Intel Technical Advisory

TA-1026-01

Correctable PCIe* bus errors reported with PCIe* Gen 3 add-in cards installed in riser cards used in the Intel® Server System R1000GZ/GL product family

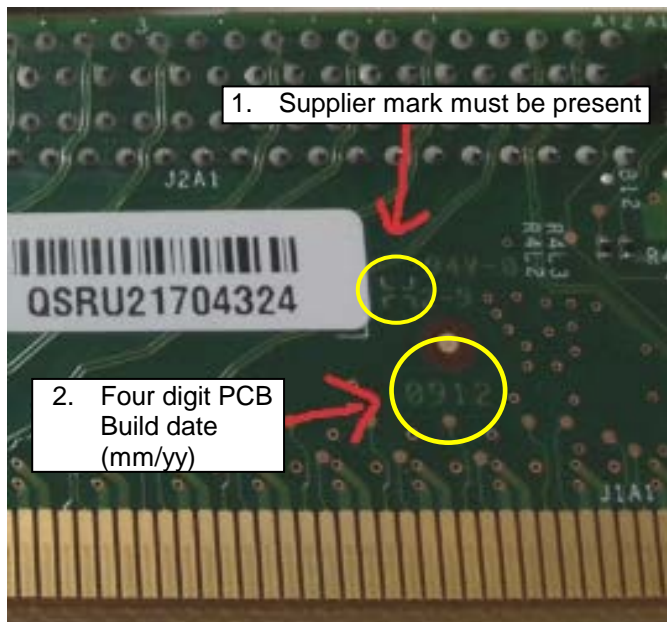
Through an internal investigation, Intel learned of a manufacturing issue with riser cards produced from a specific supplier. Affected riser cards have the inner layer ground plane extending into the gold finger area of the riser card connector. This issue impacts signal integrity for adapter cards attempting to operate at PCIe* Gen 3 speeds.

- 1.The riser card will include a specific supplier mark etched onto the back side (non-connector side) of the riser card. See photograph below.
- 2.The riser card will have a 4-digit (mm/yy) build date between and including 0412 (April 2012) and 0113 (January 2013) etched into the back side of the riser card.

The following photograph identifies a riser card that is impacted by this issue. A riser card that does NOT include the specific supplier mark is NOT affected by this issue.

Intel has worked with its riser card supplier to correct this issue. All server systems within the Intel® Server System R1000GZ/GL product family manufactured after January 2013 will not be impacted by this issue.

Customers looking to use PCIe* Gen 3 add-in cards operating at Gen 3 speeds are welcome to return the affected riser cards back to Intel for replacement riser cards. Please contact Intel using your normal warranty process, indicating that you are calling regarding TA # 1026. Have the following information when you call: the serial number(s) of the affected system(s), and the part number or PBA # of the affected item needed. Part number and PBA# can be found on a white sticker affixed to the riser card.
